## **2.5 Geology, Seismology, and Geotechnical Engineering**

In Section 2.5, “Geology, Seismology, and Geotechnical Engineering,” of the VEGP SSAR, the applicant described geologic, seismic, and geotechnical engineering properties of the VEGP ESP site. SSAR Section 2.5.1, “Basic Geologic and Seismic Information,” presents information on geologic and seismic characteristics of the VEGP site and region surrounding the site. SSAR Section 2.5.2, “Vibratory Ground Motion,” describes the vibratory ground motion assessment for the ESP site through a PSHA and develops the SSE ground motion. SSAR Section 2.5.3, “Surface Faulting,” evaluates the potential for surface tectonic and non-tectonic deformation at the ESP site. SSAR Sections 2.5.4, “Stability of Subsurface Materials and Foundations,” 2.5.5, “Stability of Slopes,” and 2.5.6, “Embankments and Dams,” describe foundation and subsurface material stability at the ESP site.

## **2.5.1 Basic Geologic and Seismic Information**

Figure 2.5.2-2 - Alternative geometries comprising the UCSS model updated Charleston seismic source (reproduced from SSAR Figure 2.5.2-9)

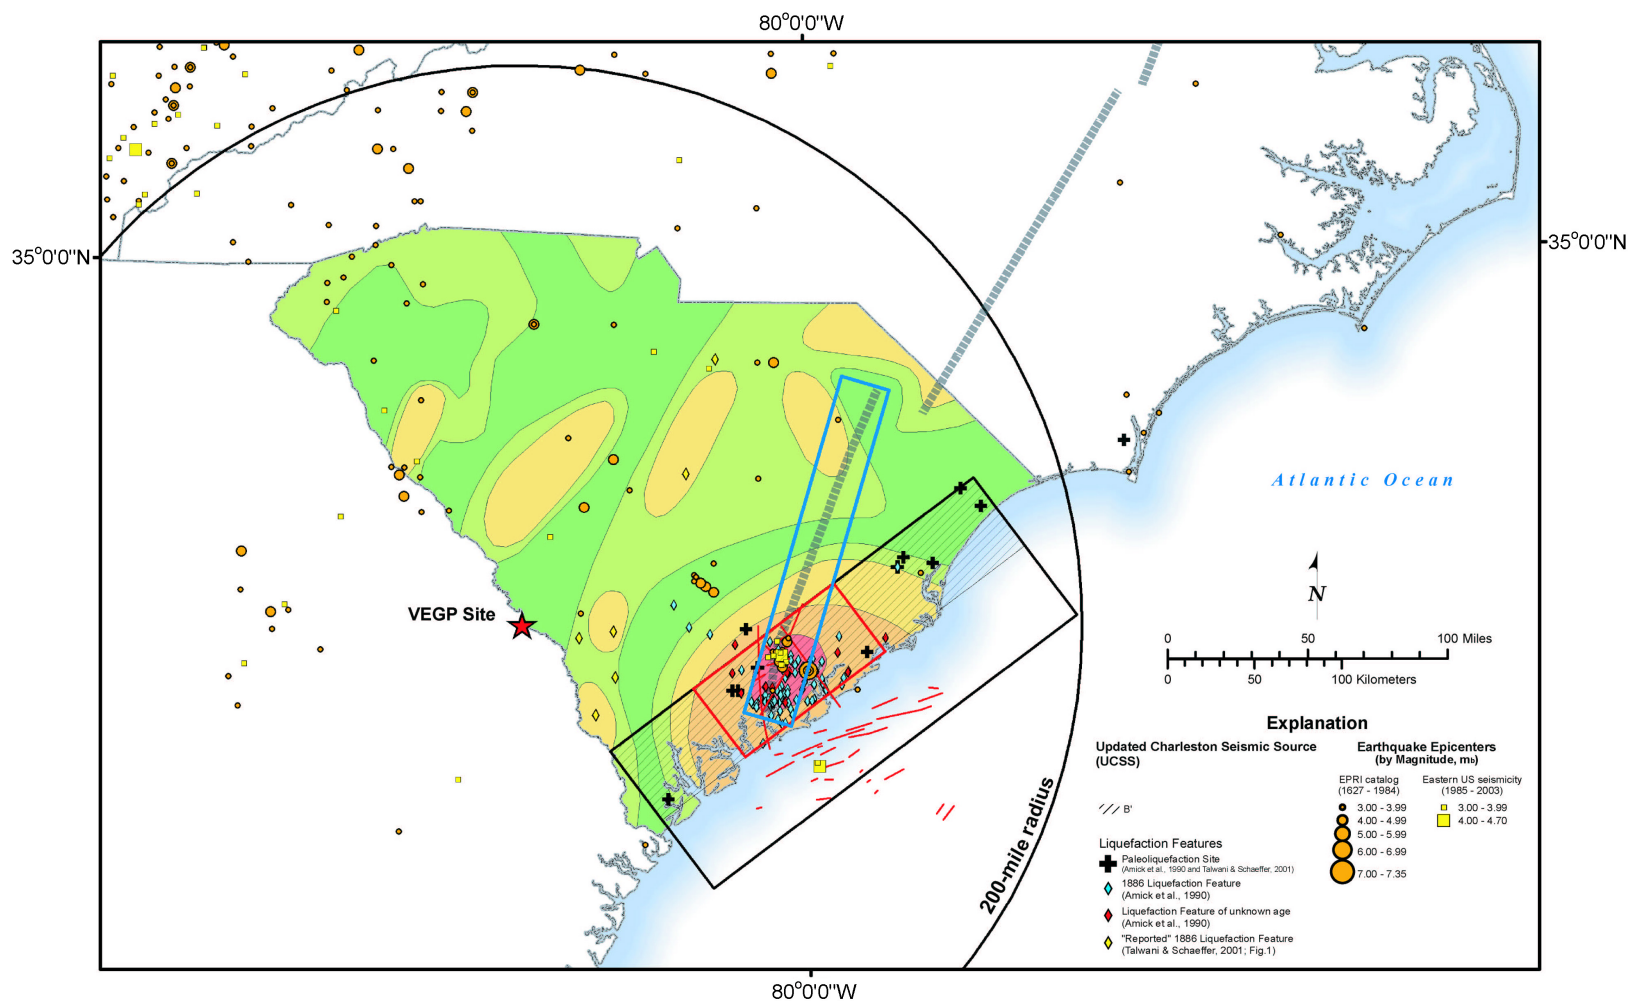
Charleston Seismic Source Zone Geometries. For its update of the Charleston seismic source zone, the applicant developed new source zone boundaries. Specifically, as described in SSAR Section 2.5.2.2.4, the applicant developed four, mutually exclusive source zone geometries, referred to as A, B, B', and C, to represent the Charleston seismic source. These four source zones are shown in SER Figure 2.5.2-2 (reproduced from SSAR Figure 2.5.2-9). SSAR Section 2.5.2.2.4.1 states that the width of Geometry B is 80 kilometers (50 miles). However, SSAR Figure 2.5.2-9 (and SER Figure 2.5.2-2) show that the width of Geometry B is

100 kilometers (62 miles). In RAI 2.5.2-14, the staff asked the applicant to provide the actual dimensions of Geometry B used for the UCSS. In response, the applicant stated that the width of UCSS Geometry B is 100 kilometers and not 80 kilometers, as stated in SSAR Section 2.5.2.2.4.1. Based on the applicant's clarification of the width of source zone B, the staff concludes that the source referred to as Geometry B in SSAR Figure 2.5.2-9 is accurate.

**Figure 2.5.2-12 - Comparison of the staff's 1-Hz hazard curves for the ETSZ for magnitudes ranging from M 6.0 to M 7.8**

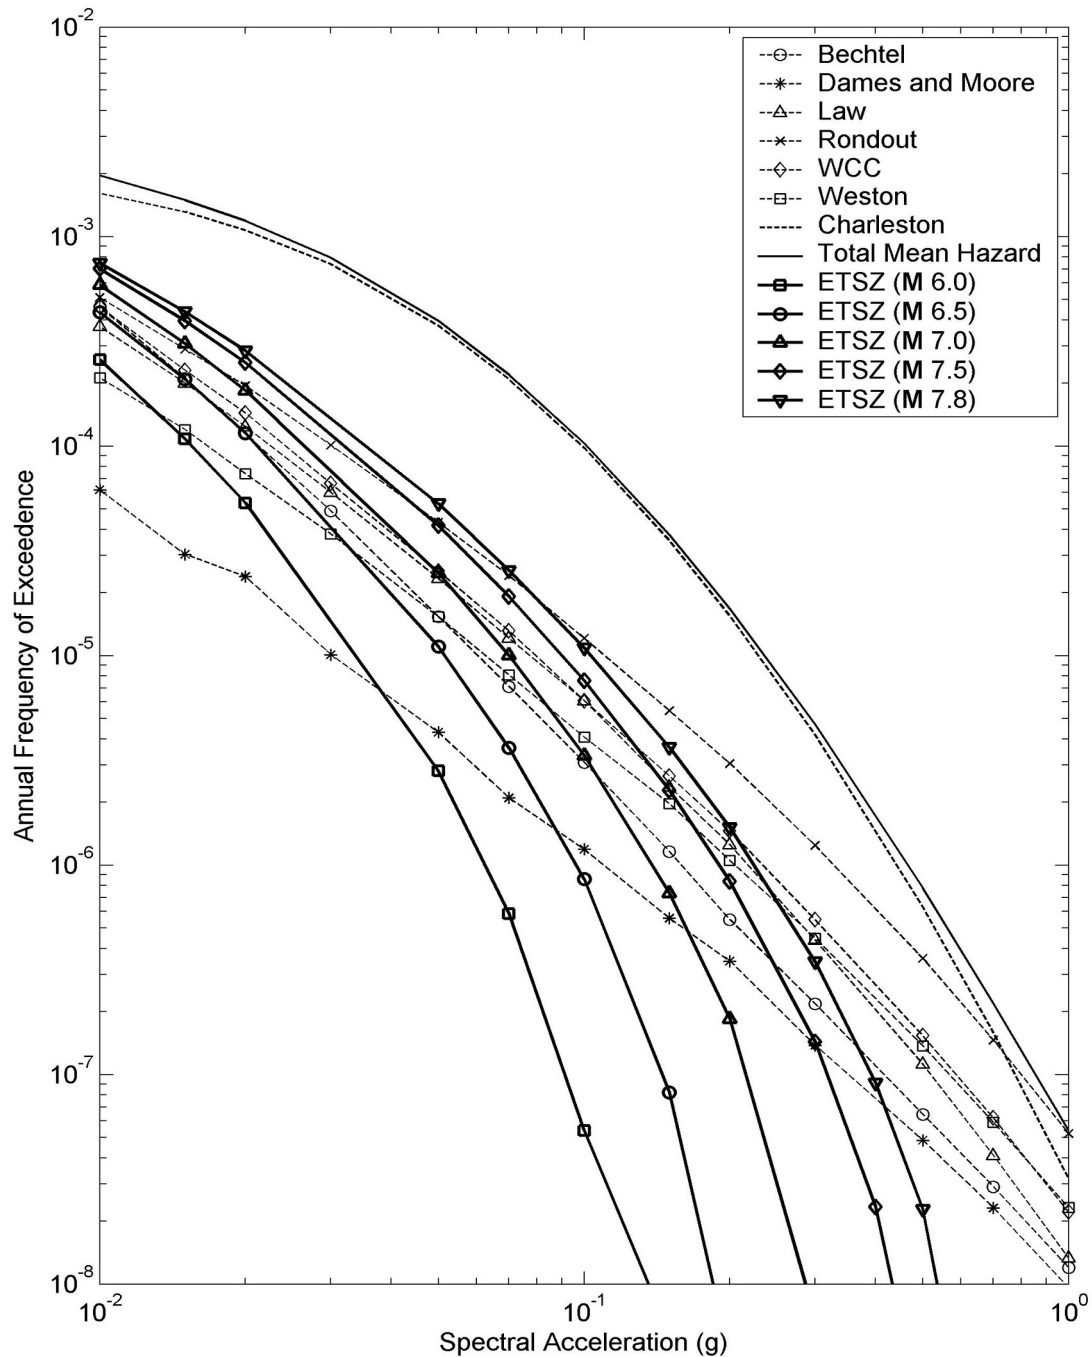
To validate the applicant's claim that the ETSZ hazard results are insignificant compared to the Charleston seismic source, the staff did a confirmatory analysis. The staff performed hazard calculations using maximum magnitudes for the ETSZ that ranged from **M** 6.0 to **M** 7.8. This magnitude range reflects more recent  $M_{\max}$  values assigned to the ETSZ, as shown in SER Table 2.2.5-6. SER Figure 2.5.2-12 shows the staff's 1-Hz hazard curves for the ETSZ using this range of  $M_{\max}$  values. SER Figure 2.5.2-12 also shows the applicant's total mean hazard curve and the Charleston seismic source zone contribution for comparison. The staff's results show that, although the Charleston seismic source zone clearly dominates the 1-Hz hazard, the

contribution from the ETSZ for some of the larger  $M_{\max}$  values (greater than 7.0) may contribute significantly more than 1 percent to the total hazard for the ESP site.

The staff concludes, however, that the contribution of the ESTZ at the Vogtle ESP site is insignificant, even when  $M_{\max}$  values comparable to the mean  $M_{\max}$  values for the TIP and Geomatrix studies are considered. Based on the staff's sensitivity study, presented in SER Figure 2.5.2-12, a mean magnitude of **M6.5** for the ETSZ contributes to less than 1 percent of the total hazard at 1 Hz for ground motions critical for design levels (0.1 g and higher). Therefore, the staff considers Open Item 2.5-3 to be resolved.

**Figure 2.5.2-13. Composite EPRI-SOG distribution in terms of M compared to more recent assessments (reproduced from the Bellefonte RCOL application)**

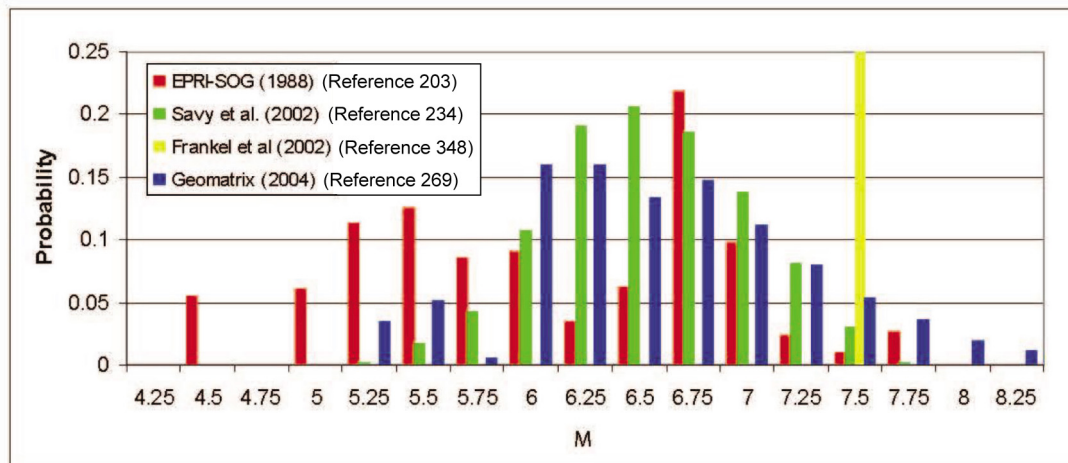
The staff disagrees with the applicant's conclusions that additional calculations of seismic hazard with larger  $M_{\max}$  for the ETSZ are not warranted. The staff notes that there are more recent seismic hazard studies, such as the LLNL TIP study and the Geomatrix TVA Dam safety study, which provide new information on the seismic hazard of the area. Furthermore, the staff does not agree with the applicant's conclusion that the EPRI team's  $M_{\max}$  composite distribution for the ESTZ is similar to that of more recent studies. The applicant only compared the range of the  $M_{\max}$  values of the EPRI study rather than the actual weighted values. SER Figure 2.5.2-13 clearly shows that more recent studies place a significantly higher probability on larger maximum magnitude earthquakes than the EPRI study. The mean  $M_{\max}$  for the TIP (i.e. Savy et al., 2002) and Geomatrix studies are approximately **M6.55** and **M6.58**, respectively.

**Figure 2.5.2-14 – Geographic Distribution of Liquefaction Features Associated with Charleston Earthquakes (SSAR Figure 2.5.2-12a)**

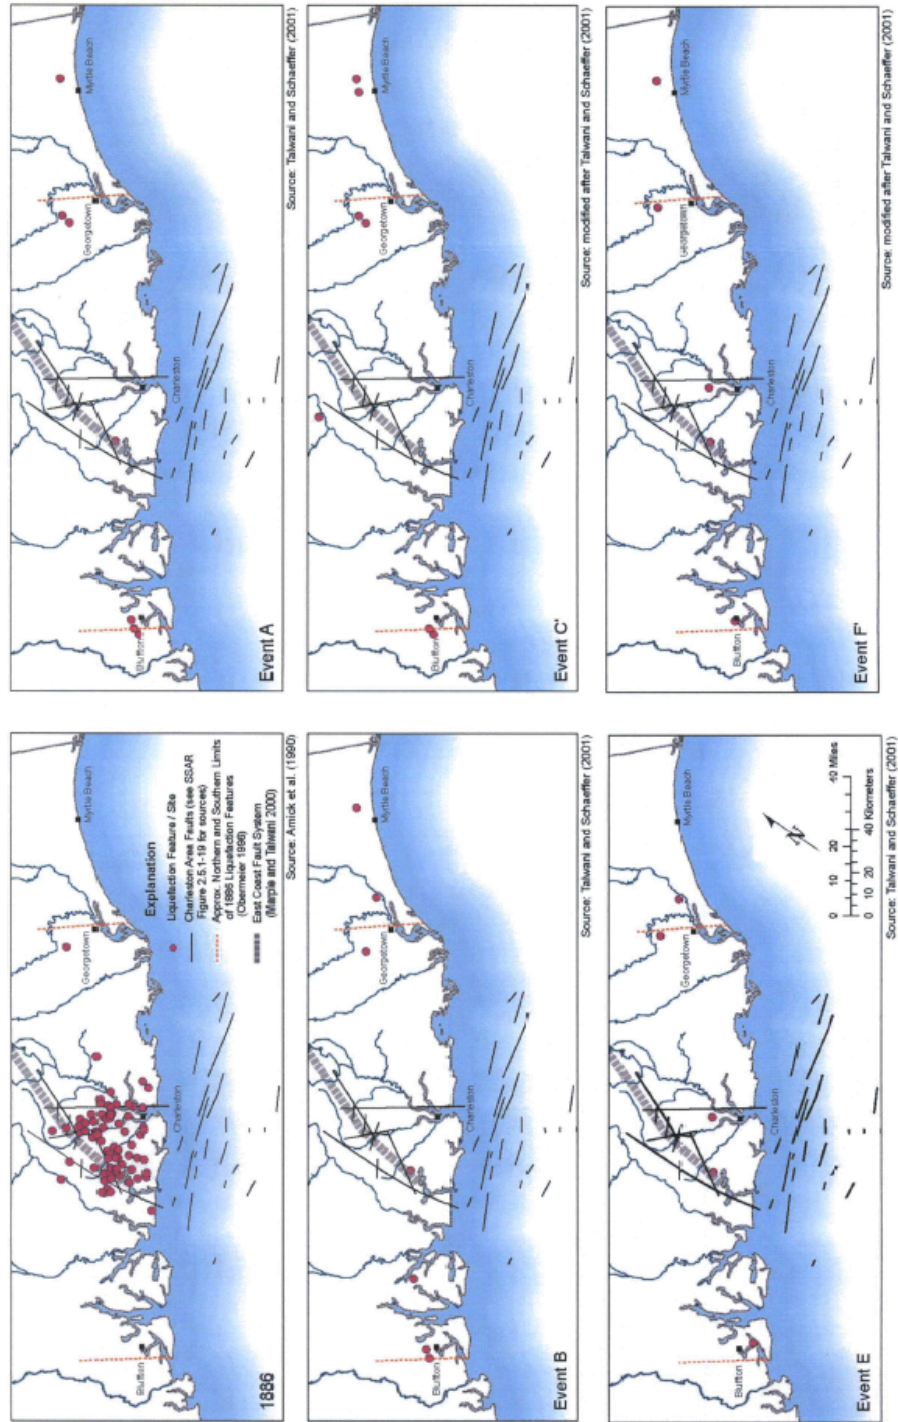
The applicant provided a visual depiction of this information (SER Figure 2.5.2-14) to allow a comparison of liquefaction features associated with Talwani and Schaeffer (2001) events C and D to determine any overlap that could provide further evidence that these two events should be combined into a single event, C'. The applicant stated that liquefaction features associated with events C and D are localized and do not show any spatial overlap and "therefore do not provide definitive geographic evidence for combining these events into a single, large event C'." However, the applicant chose to include a single, large event C' (as opposed to two smaller events C and D) into the updated Charleston seismic source model based on the following three reasons:

**Figure 2.5.2-15 – Liquefaction Sites for Events C, C, and D (Applicant Response to RAI 2.5.2-11, Figure 2.5.2-11)**

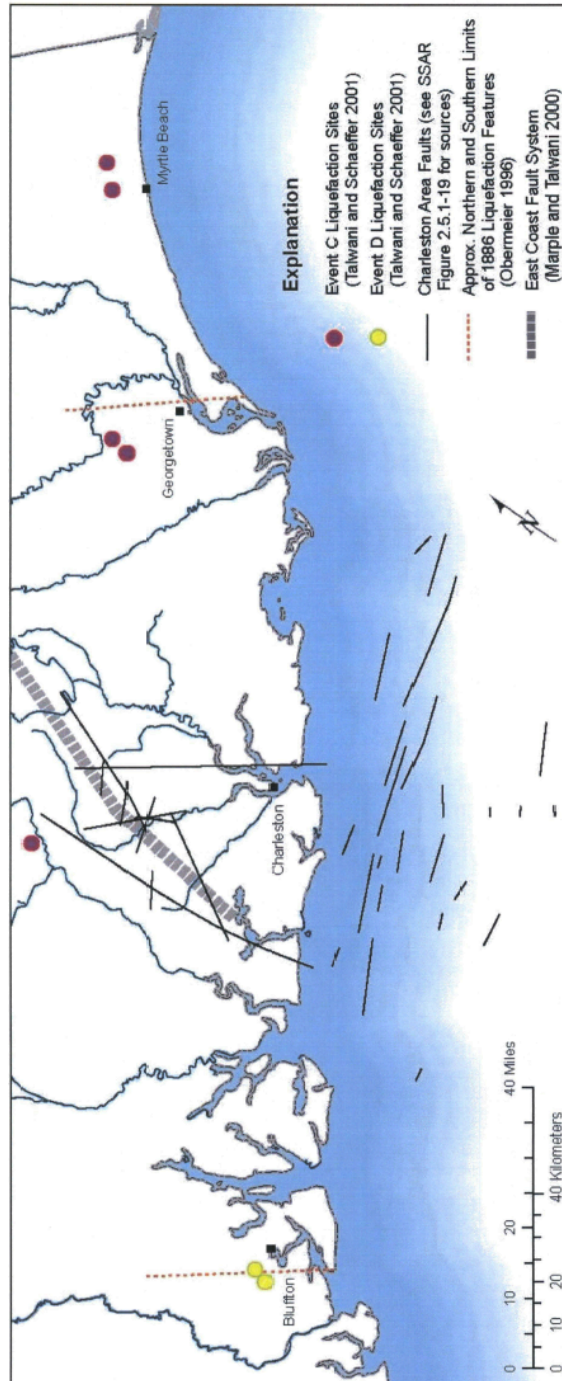
3. The distribution of paleoliquefaction sites for Event C' is very similar to the coastal extent of liquefaction features from the 1886 earthquake. Moreover, the distribution and number of paleoliquefaction sites for Event C' are very similar to those for Events A and B, the two best documented prehistoric events (SER Figure 2.5.2-15).

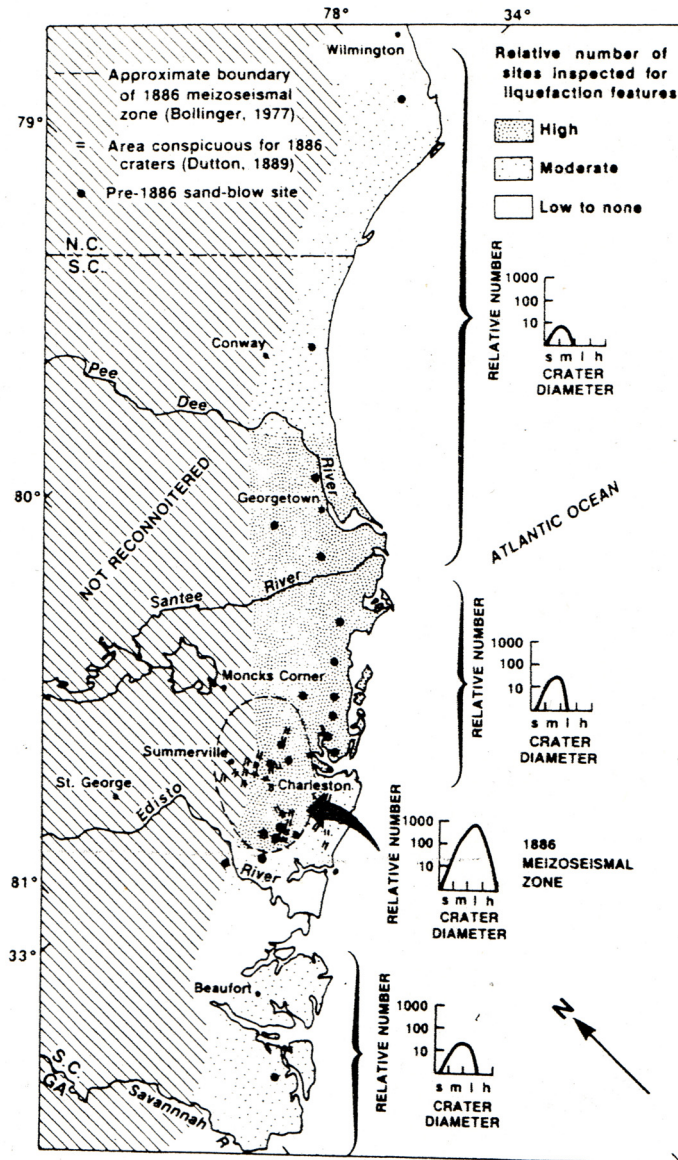
The staff also reviewed the study of Obermeier et al. (1989). Obermeier et al. (1989) conclude that, "Both the size and relative abundance of pre-1886 craters are greater in the vicinity of Charleston (particularly in the 1886 meizoseismal zone) than elsewhere, even though the susceptibility to earthquake-induced liquefaction is approximately the same at many places throughout this coastal region." Figure 4 of Obermeier et al. (1989), reproduced as SER Figure 2.5.2-16, depicts the sizes of various prehistoric liquefaction features and demonstrates that the largest craters of all ages concentrate near Charleston. The staff notes that the figure cannot exclude the possibility that one (or more) of the large prehistoric earthquakes created its (or their) largest liquefaction features elsewhere. However, Obermeier's (1989) figure shows four size classes of craters, with the largest prehistoric craters (wider than 3 meters) present only in the 1886 meizoseismal area. Only smaller craters are known farther south and north. Obermeier (1989) favors attributing some of these distant, small-to-medium-sized craters to infrequent moderate earthquakes at two separate sources far north and south of Charleston. The epicentral regions of 1886-sized earthquakes should have abundant craters wider than 3 meters, and they have been found only near Charleston. Sparse exposures preclude saying much about crater sizes between Beaufort and the Edisto River, south of Charleston (Obermeier et al. 1989) and south of Geometry A. Thus, it is unlikely, but possible, that the paleoliquefaction record of a large earthquake's meizoseismal region could be concealed south of Geometry A. However, this small probability is accounted for by Geometries B and B', which span most of the length of South Carolina's coast. The absence of known abundant paleoliquefaction features in North Carolina and Georgia, despite searches there (Amick and Gelinas 1991), suggests that Geometries B and B' need not extend beyond South Carolina.

Accordingly, the staff concludes that the applicant's use of a small area to represent the sources of the 1886 and all previous large earthquakes is adequate. Available evidence suggests it is likely that 1886-sized earthquakes occurred mostly or entirely within a small area like Geometry A. Evidence provided by the applicant in response to previous Open Item 2.5-5, further supports a localized source contained within Geometry A.
